FREEDOM OF INFORMATION COVERSHEET

FOI reference: 24-051

CIVIL ENGINEERING REPORT: OPERATIONAL ACCEPTANCE

CIVIL ENGINEERING REPORT: OPERATIONAL ACCEPTANCE
STAGE 2 WORKS

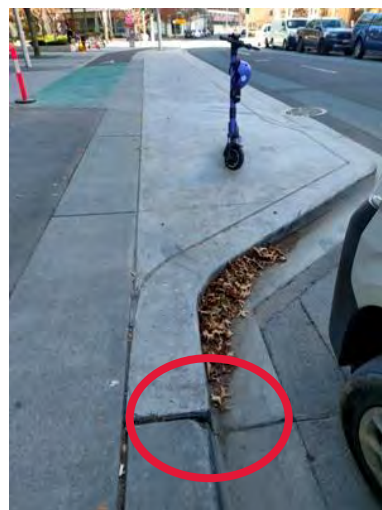
Defect:

Spalling of concrete kerb.

Meriton Group to infill area around parking ticket machine to TCCS requirements.

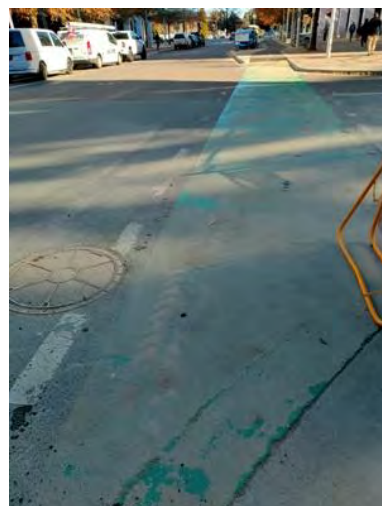
Defect:

Cycle path and road line marking condition deteriorated.

Meriton Group are to replace the line marking.

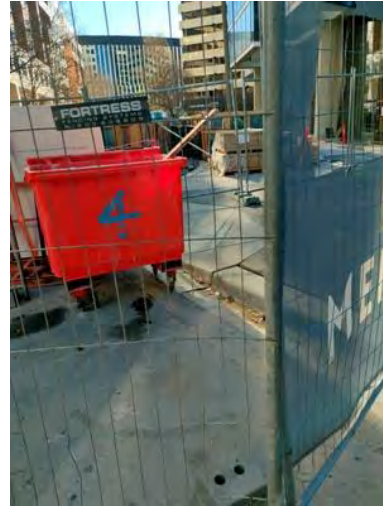
Defect:

Tactile ground surface indicators missing from pram ramp.

Construction materials in the Stage 1 TCCS Operational Acceptance area.

Meriton Group are to install the tactile ground surface indicators.

Meriton Group are to remove all construction materials from the Stage 1 TCCS Operational Acceptance area.

A typical transition done at crossing point or driveway between the 150mm and 300mm wide top kerbs. **Image-5.**

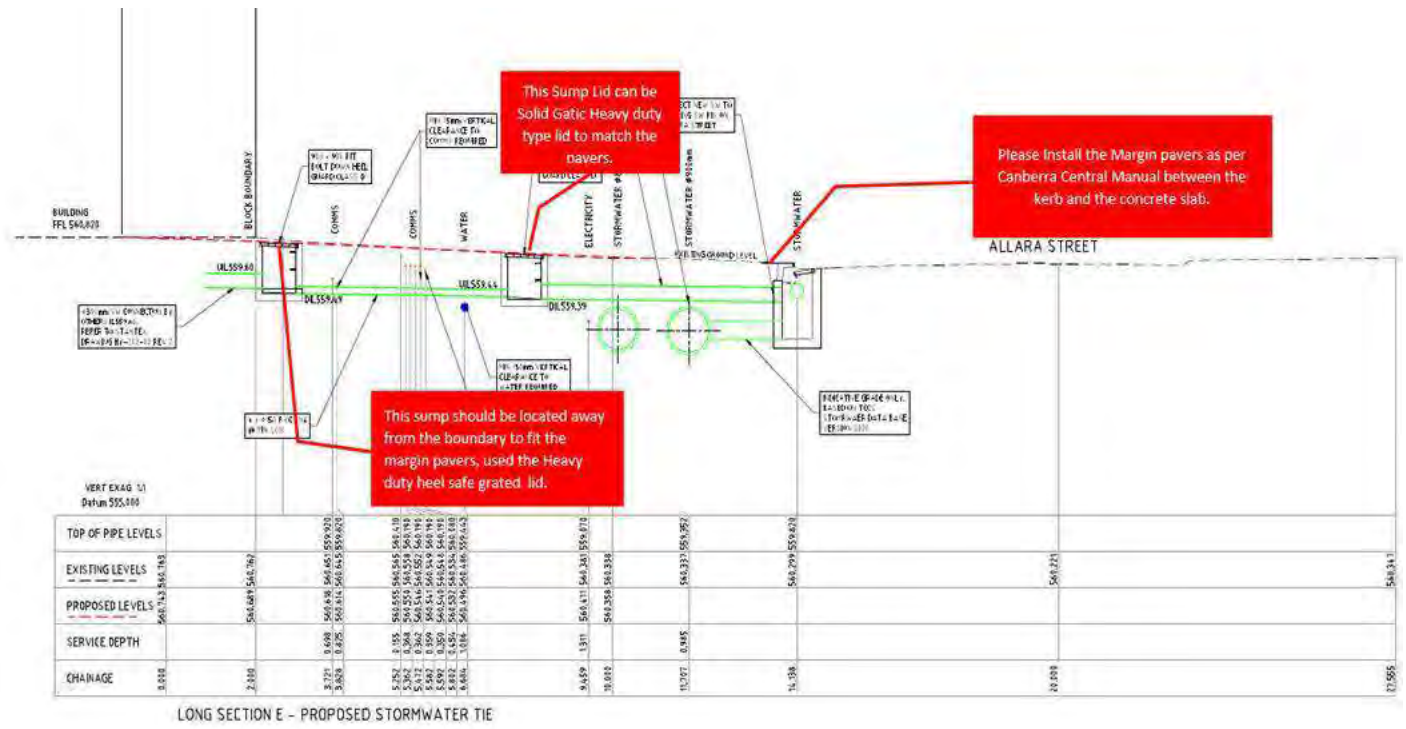
Where there is constraints of space for the margin paver between the concrete slab and the kerb, the slab must have a expansion\isolation joint between.

For the typical transition between the 150mm and 300mm wide top kerbs see the Image-5 below as example where to place the transition between the kerbs.

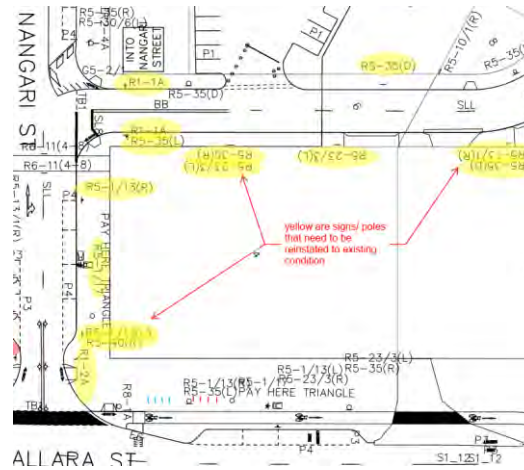
Defect:

Existing TCD signs to be reinstated as per the existing site condition

Rectification:

Meriton Group to rectify Signage.

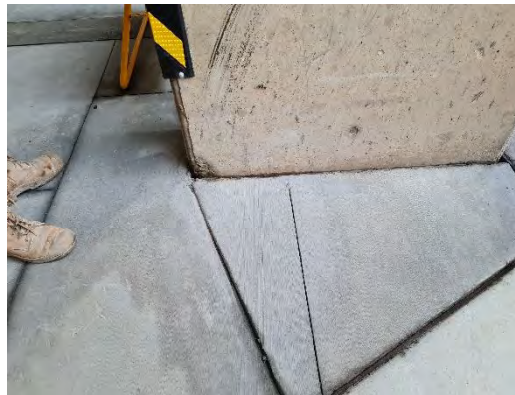
Defect:

Paving joint has not been completed in front of column

Rectification:

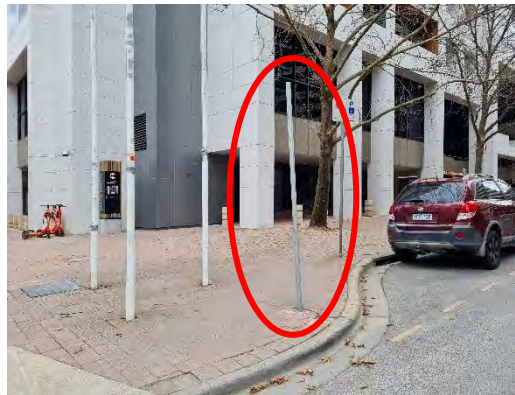
Defect:

Empty pole that was used for construction signage is still in place and should be removed.

Rectification:

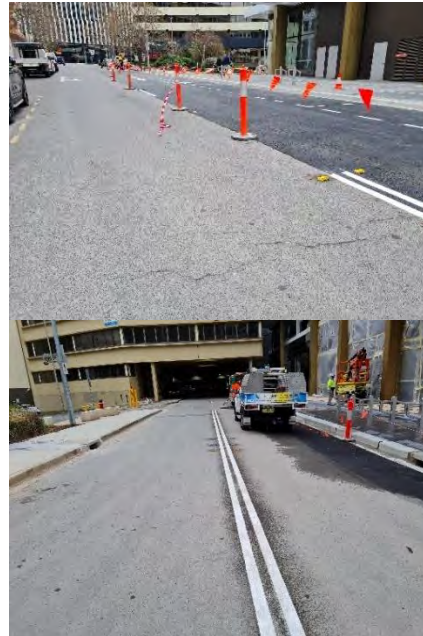
Defect:

Construction signage, vehicles, TTM's and similar elements are still in place onsite.

Rectification:

All construction-based elements are to be removed from site and site demobilized and returned to previous or better condition (undertake general site tidy up)
